CITY OF TAYLOR, TEXAS

ZONING BOARD OF ADJUSTMENT MEETING

PZ-2022-1559

Staff Report

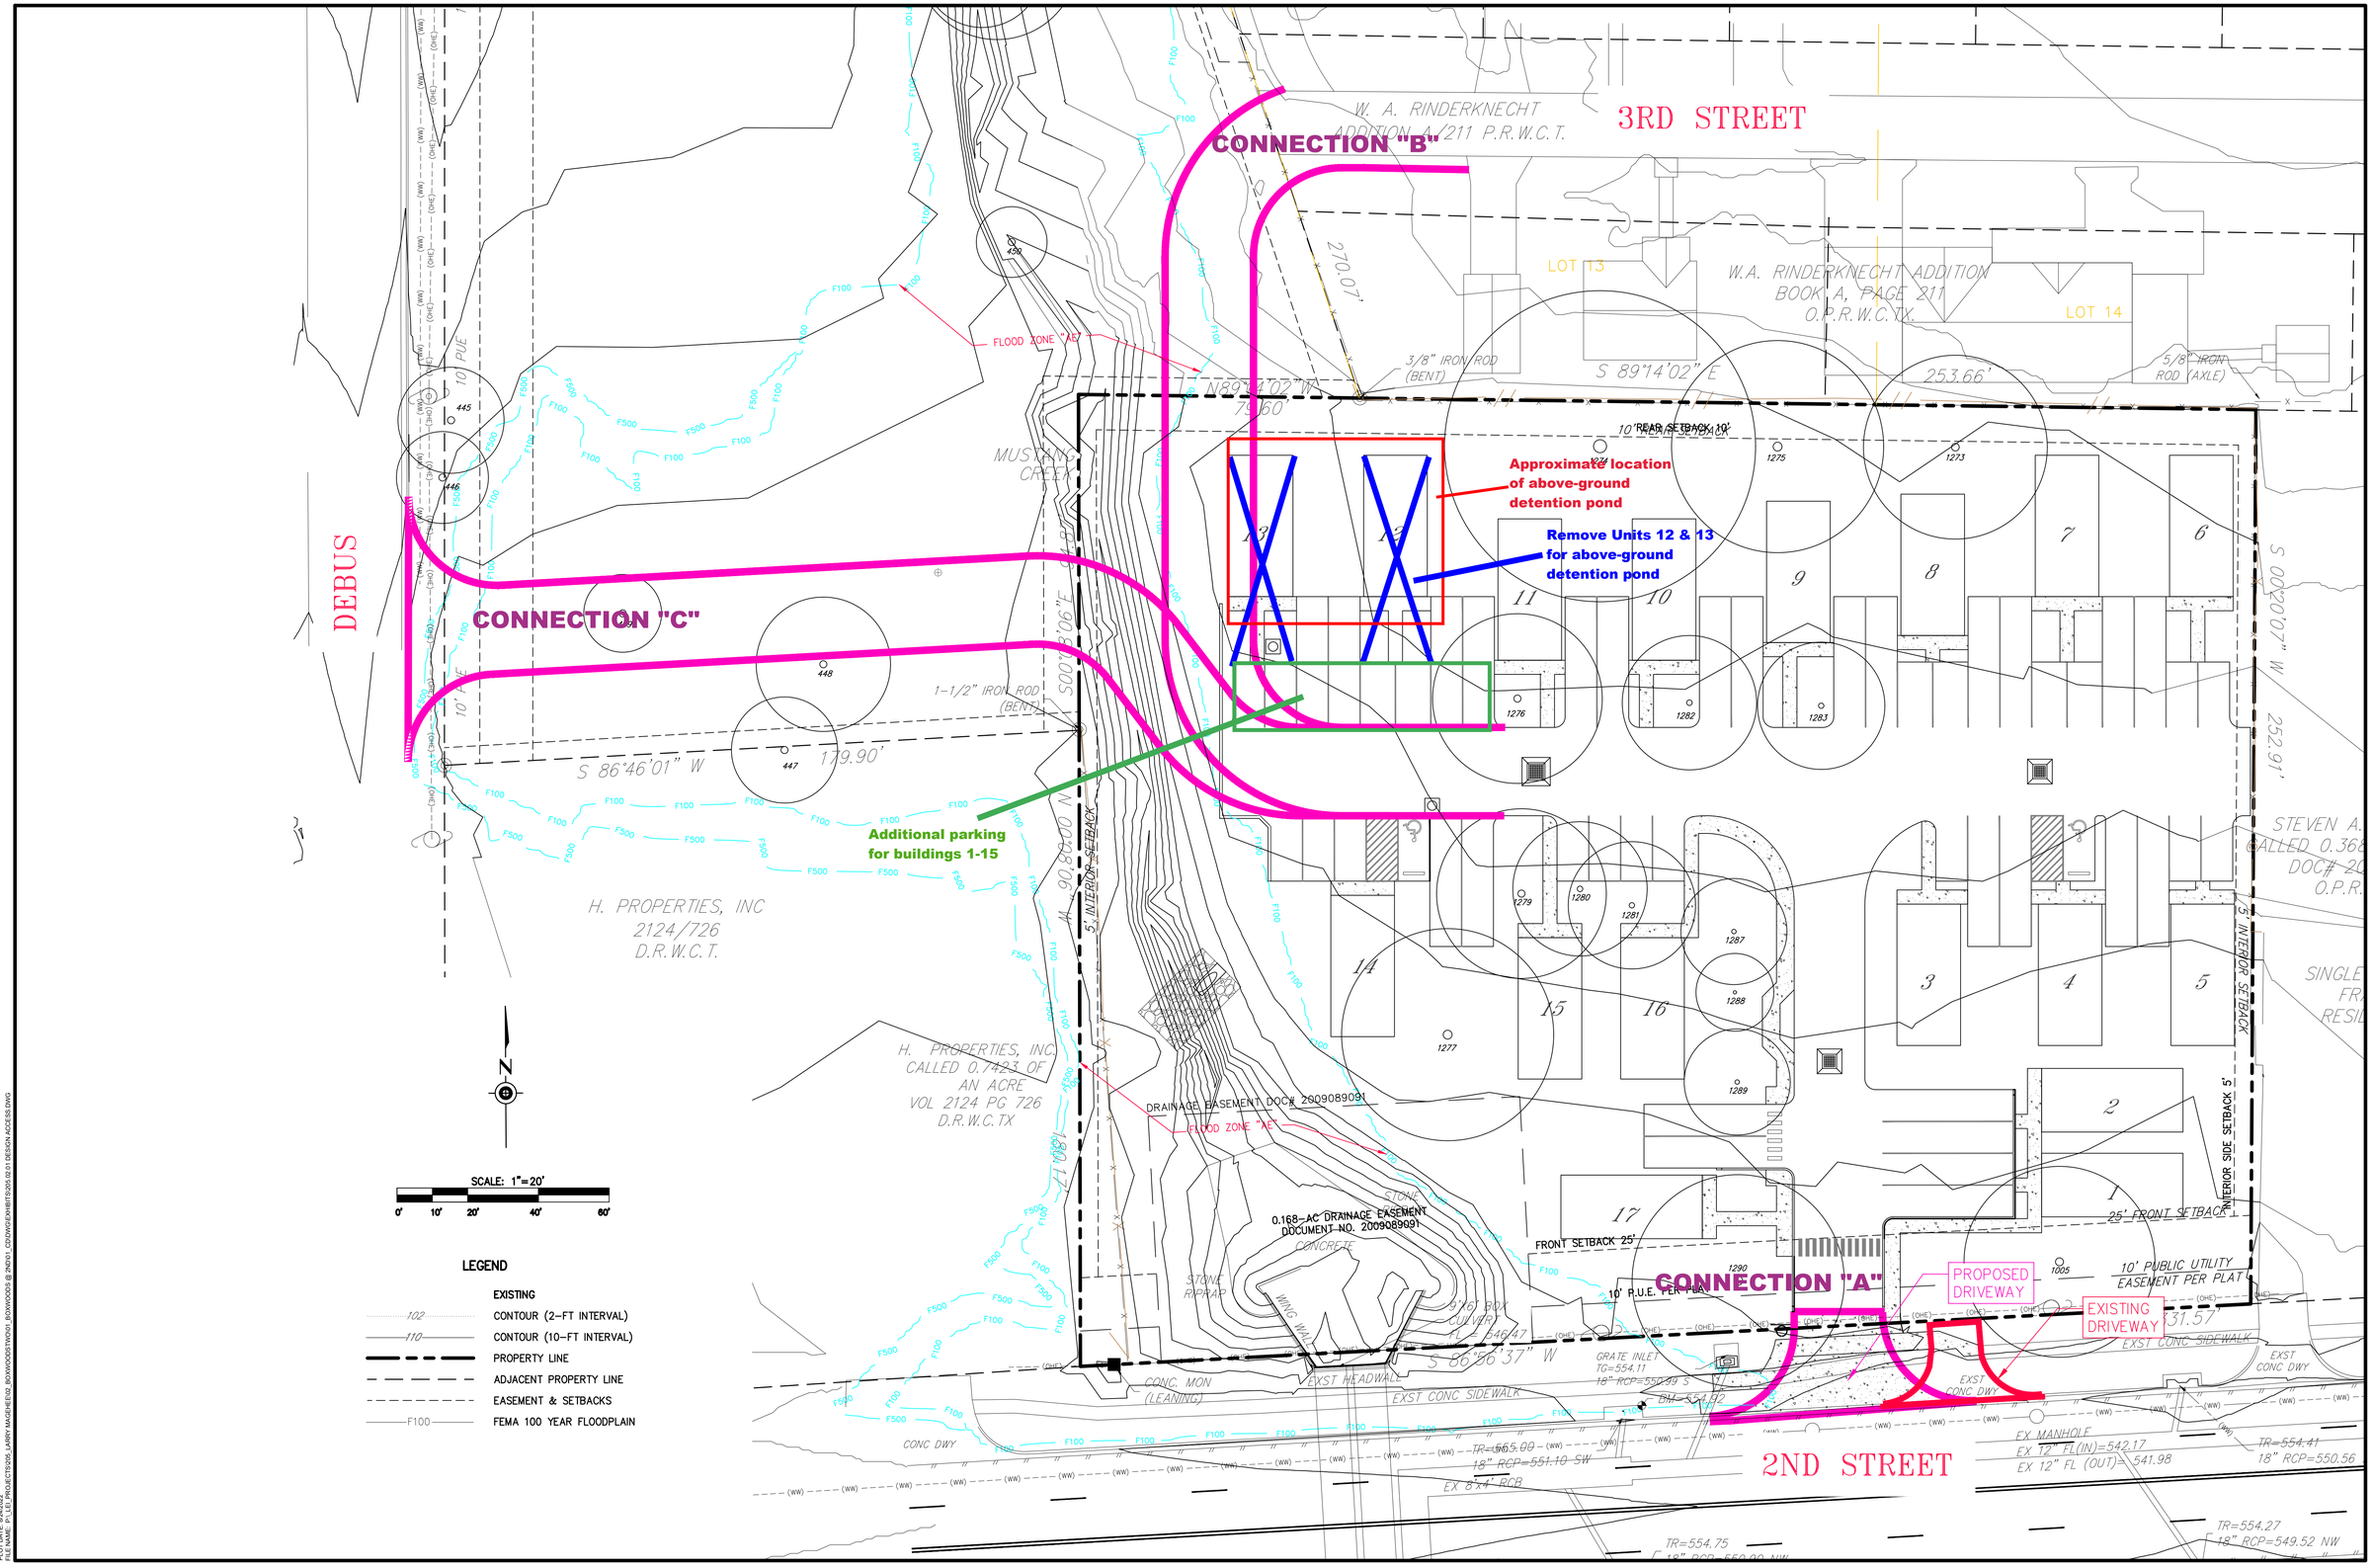
4. The proposed variance/amendment will not adversely affect adjacent or nearby properties. Although the driveway will be widened for fire protection access, the driveway location is essentially in the same location as the current, existing driveway, onto West 2nd Street, connection "A" (see exhibit – site plan).

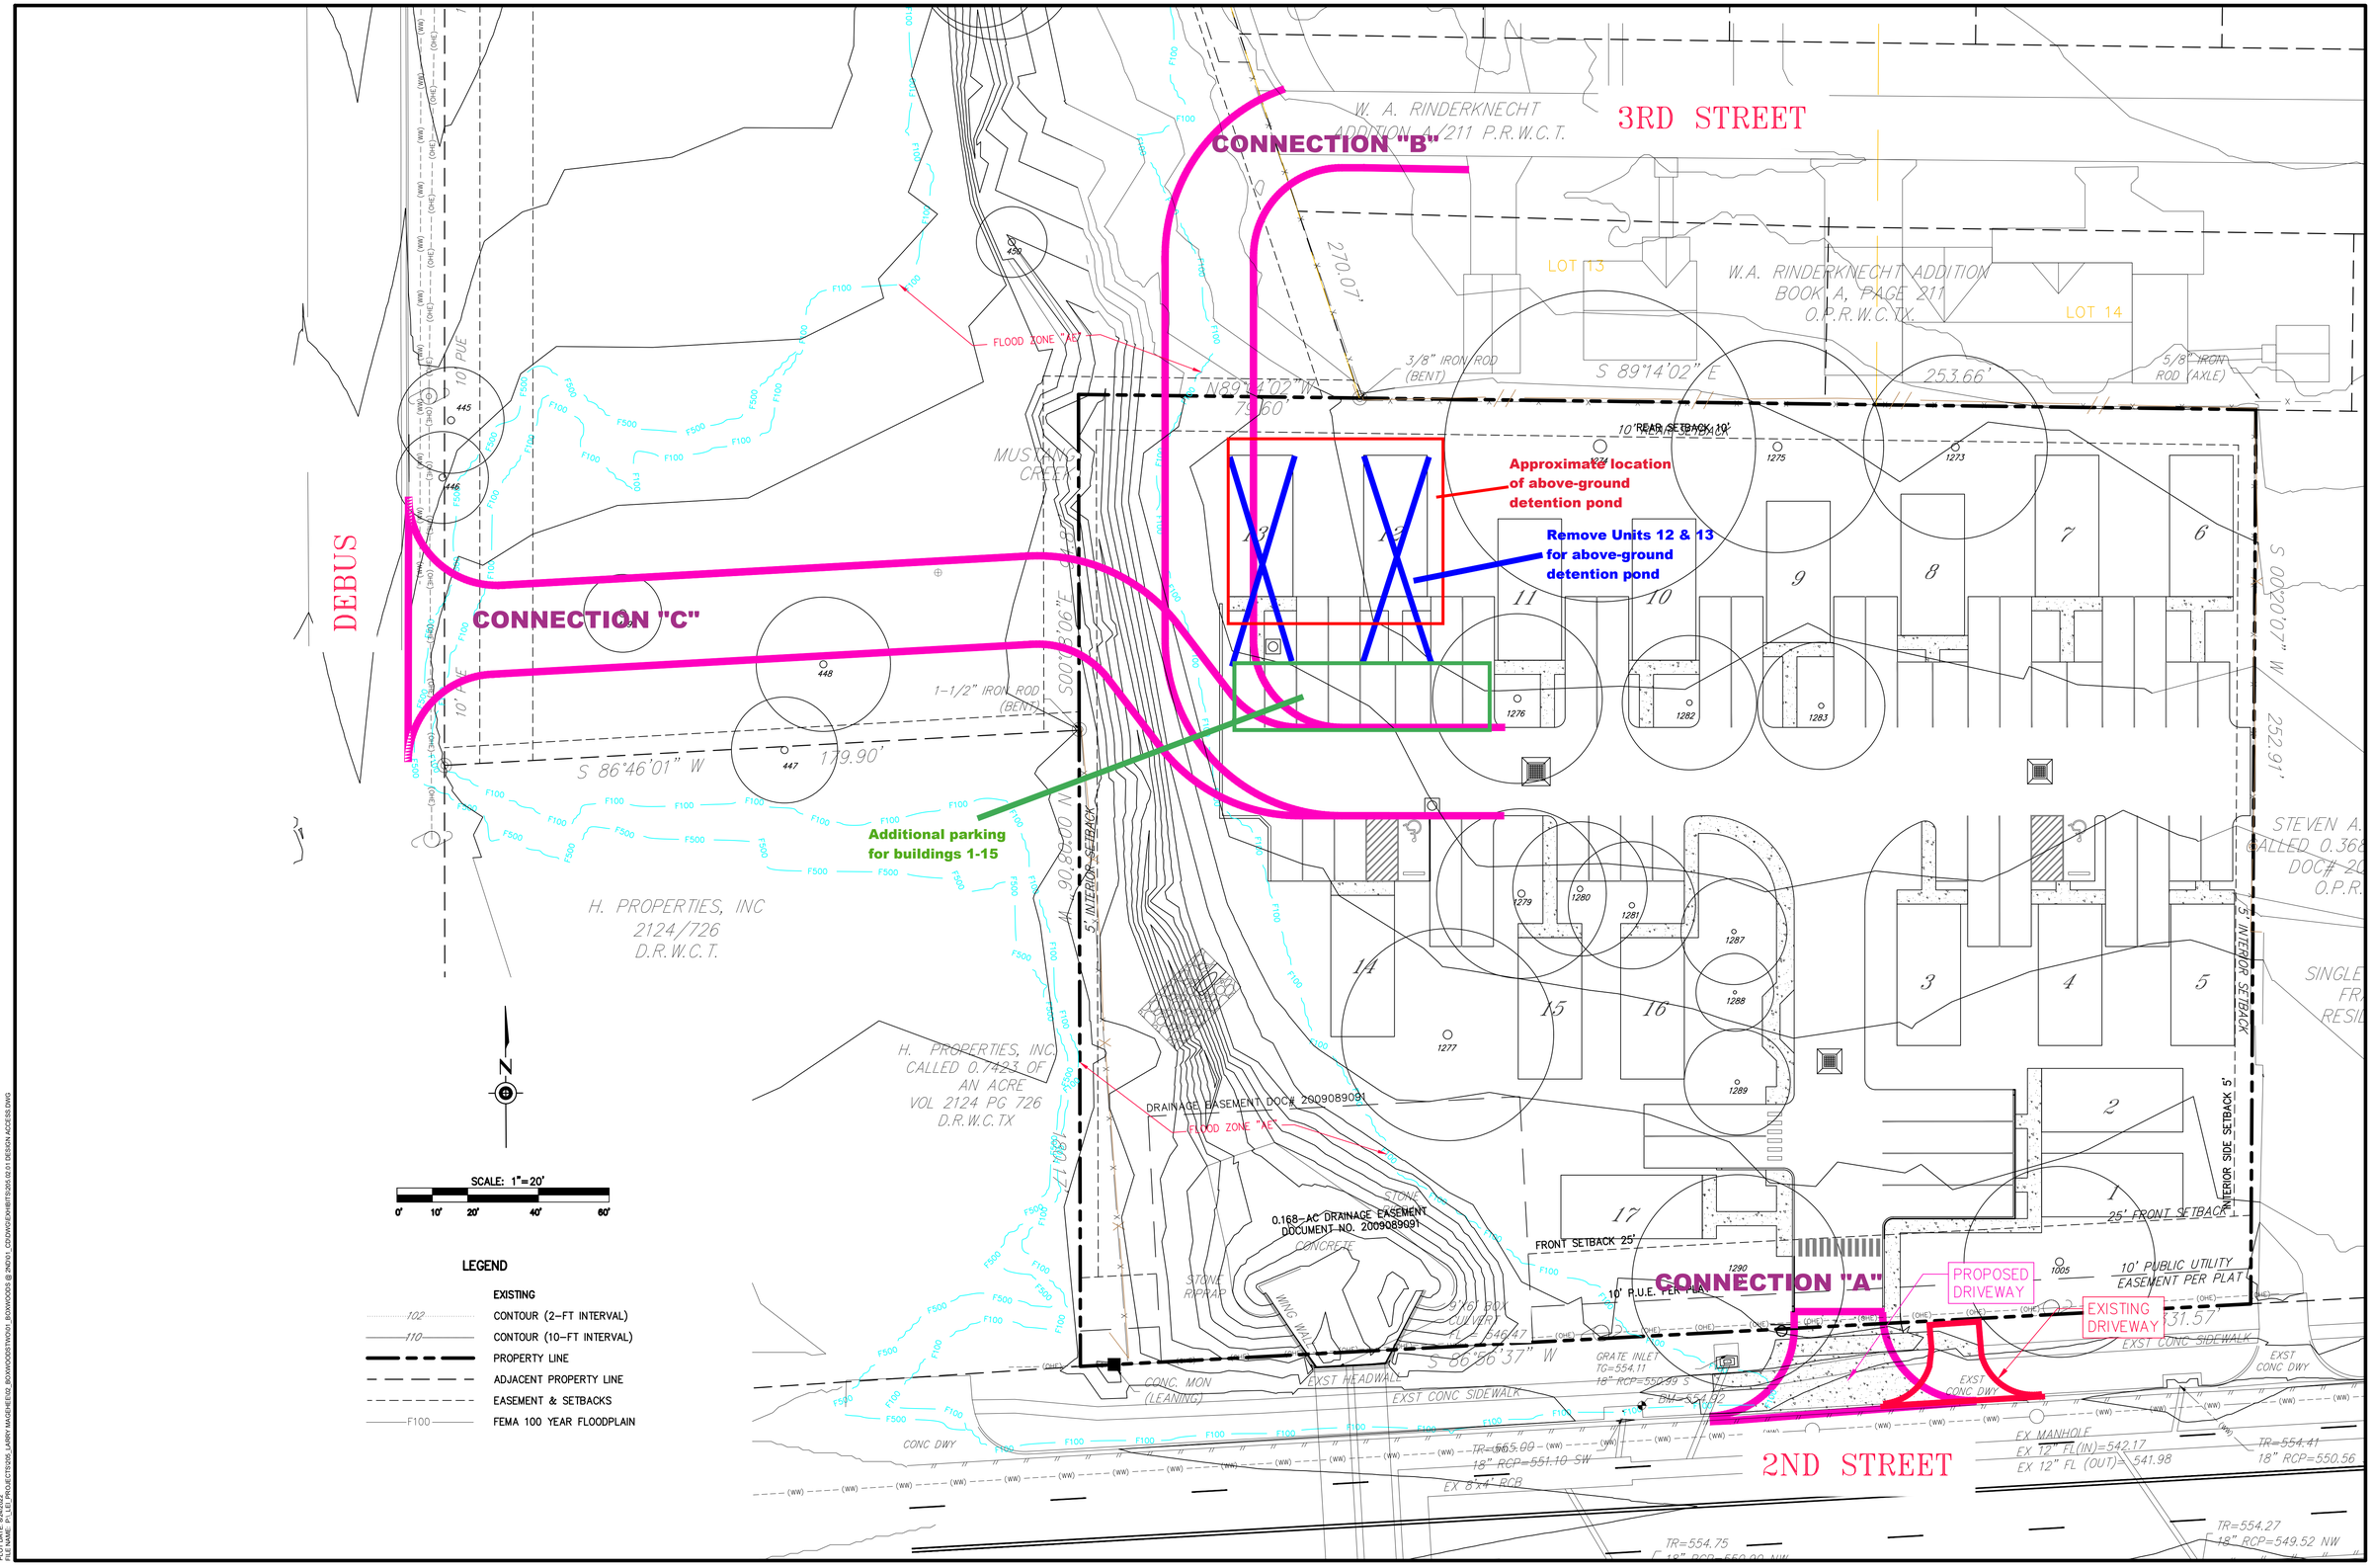
There are alternative methods to access this property, i.e., “Connection B” from W. 3rd St. and “Connection C” from Debus Dr., as shown in the attached Exhibit A. The applicant has rejected the ability of “Connection B” stating that it would create an imperfect turning radius for emergency vehicles, however they did not demonstrate this issue through an engineering analysis. The utilization of “Connection C” was determined by the applicant to have impacts to the floodplain and require access through private property. The applicant has mentioned that “Connection C" would impact the floodplain, but the applicant has not provided adequate documentation that supports this claim. While there may be additional cost associated with crossing the floodplain, such as the installation of box culverts, driveway and street crossings of a floodplain are routine.

Given this information, staff recommends denial of the zoning variance request.
